## ADDENDUM IDAP REPORT

<b>Property:</b>	14 Amaroo Avenue STRATHFIELD Lot: 63 DP: 35995 DA2021.294
<b>Proposal:</b>	Demolition of existing structures, construction of a two (2) storey dwelling house with basement level, front fence, attached shed and ancillary landscaping.
<b>Applicant:</b>	T Taouk
<b>Owner:</b>	R Magale
<b>Date of lodgement:</b>	12 November 2021
<b>Notification period:</b>	19 November 2021 to 3 December 2021
<b>Submissions:</b>	1
<b>Assessment officer:</b>	G Choice
<b>RECOMMENDATION OF OFFICER:</b>	REFUSAL

Figure 18: Amended shadow diagrams at 12pm winter

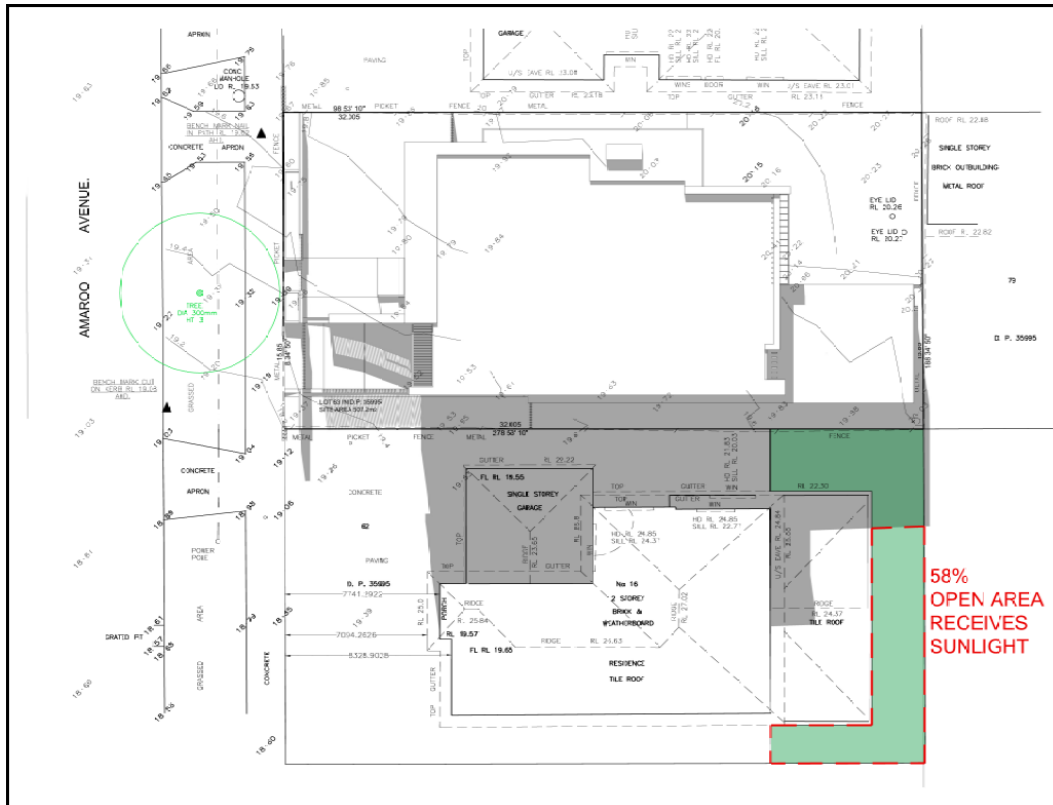
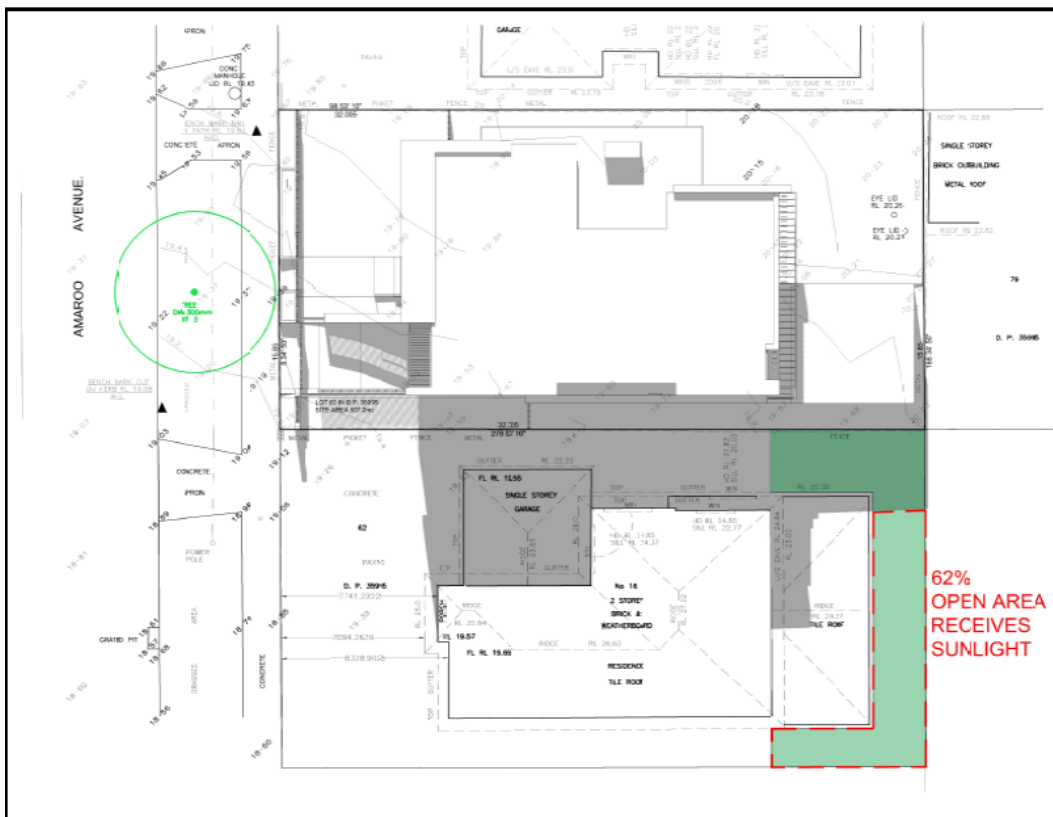
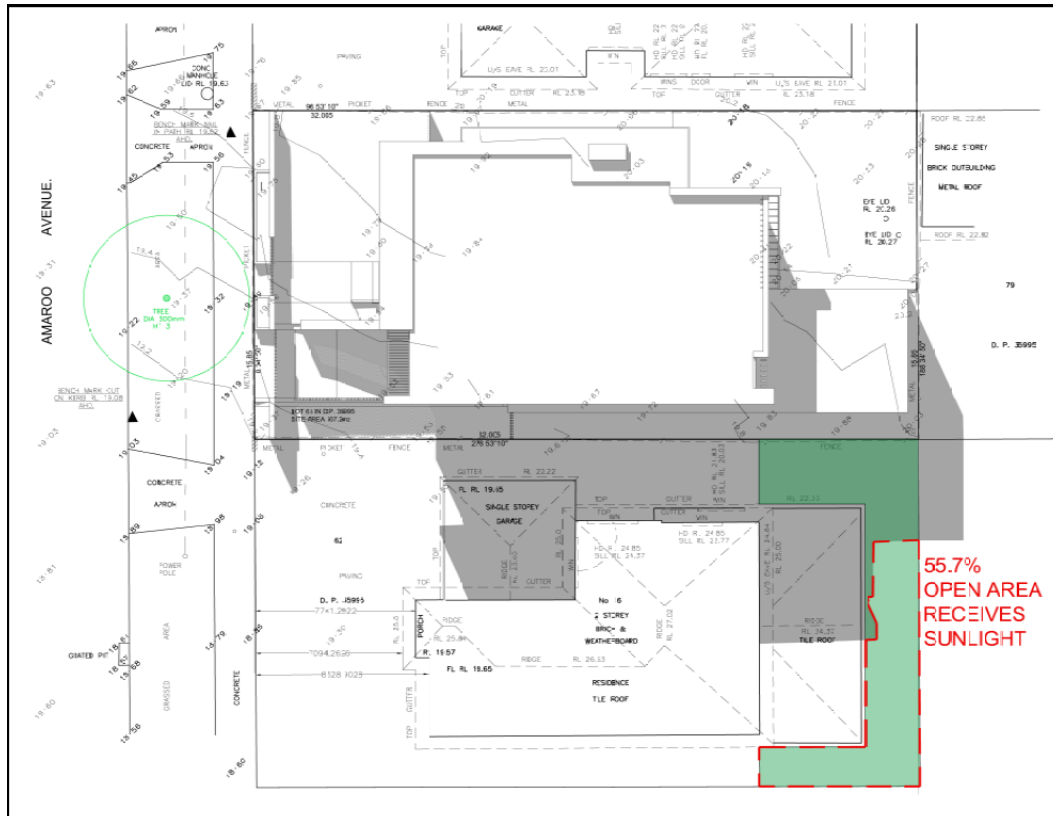
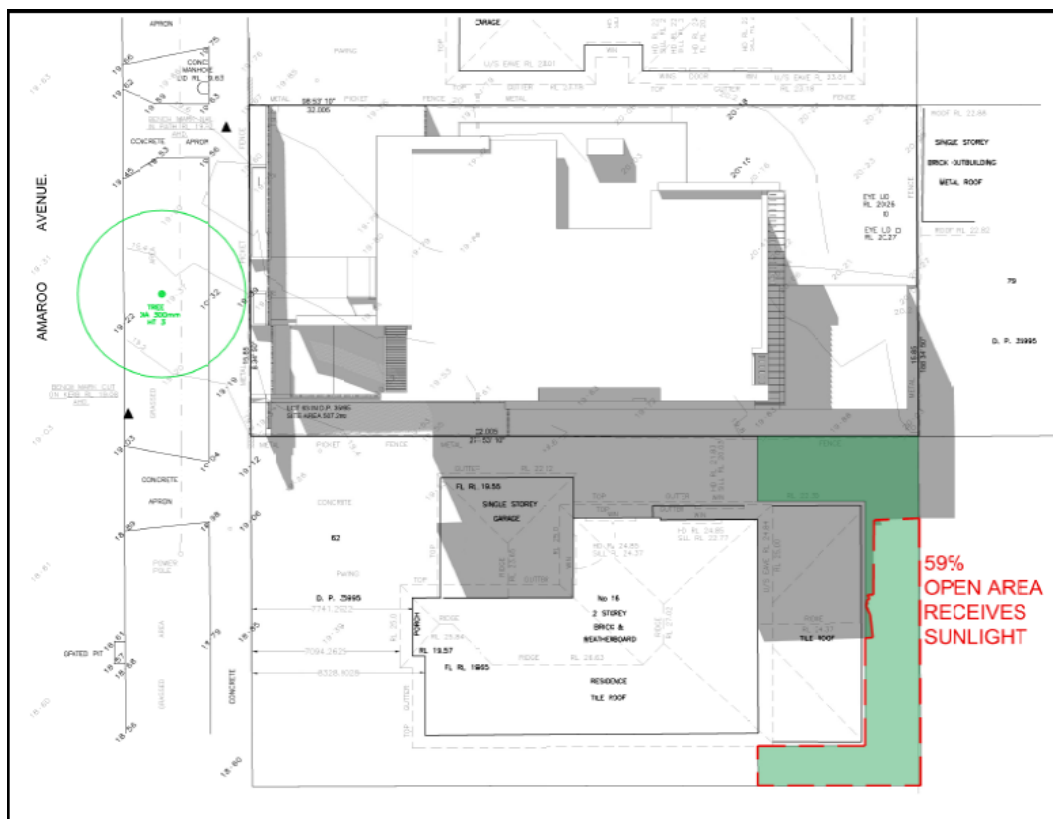
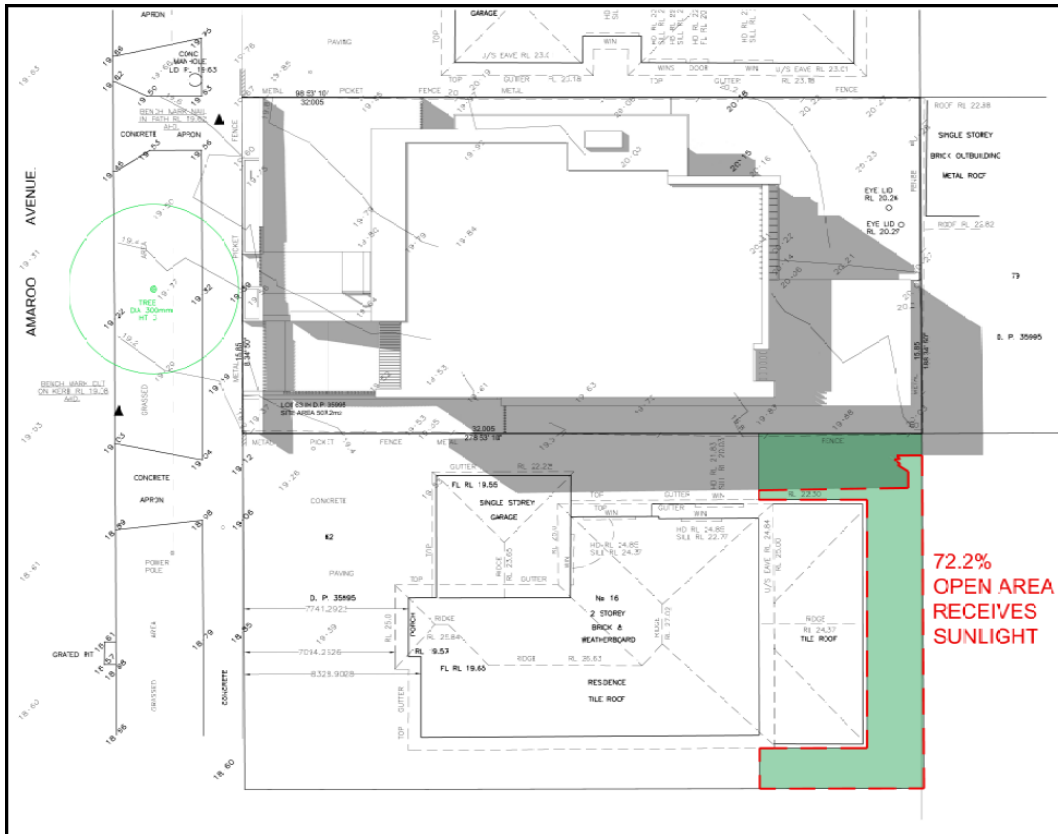
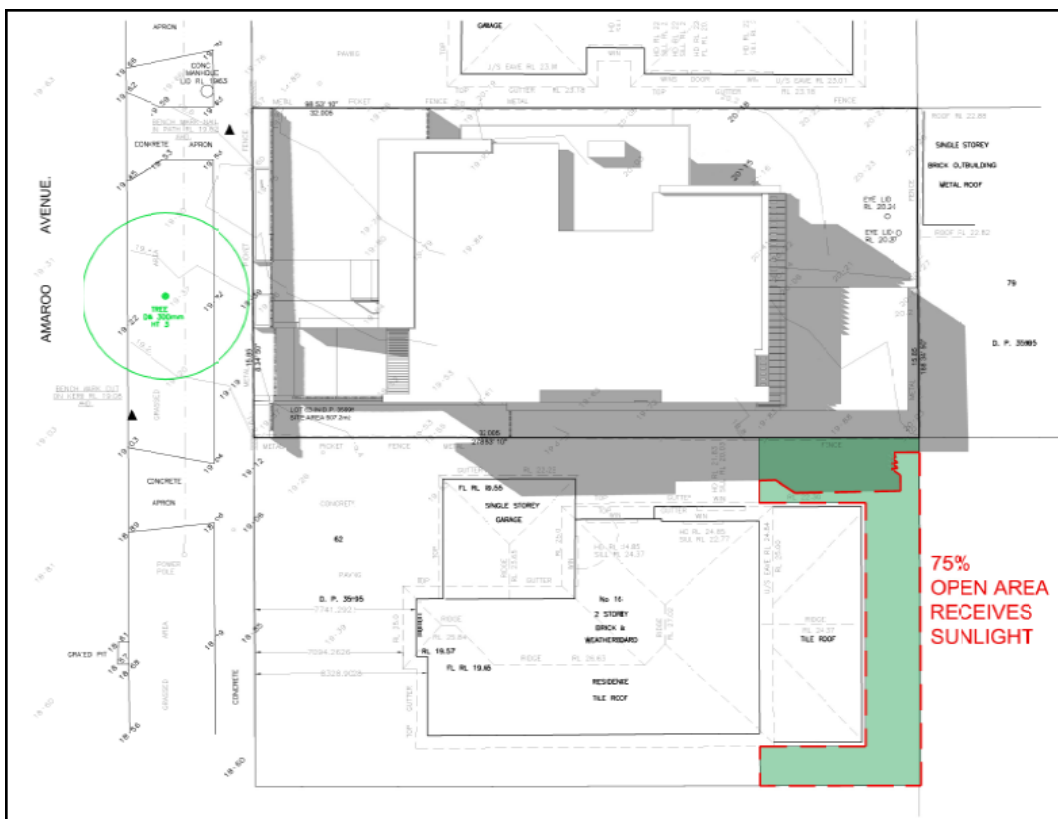
Amended shadow diagrams show a marginal increase in solar access to the north-east bounds of the rear yard at 16 Amaroo Avenue (see **Figure 11** to **Figure 24**). It is considered the proposed development (as amended) does not reflect the recommended design changes as per the IDAP comments and the issues raised by the IDAP with regard to bulk and overshadowing have not, therefore, been adequately addressed.
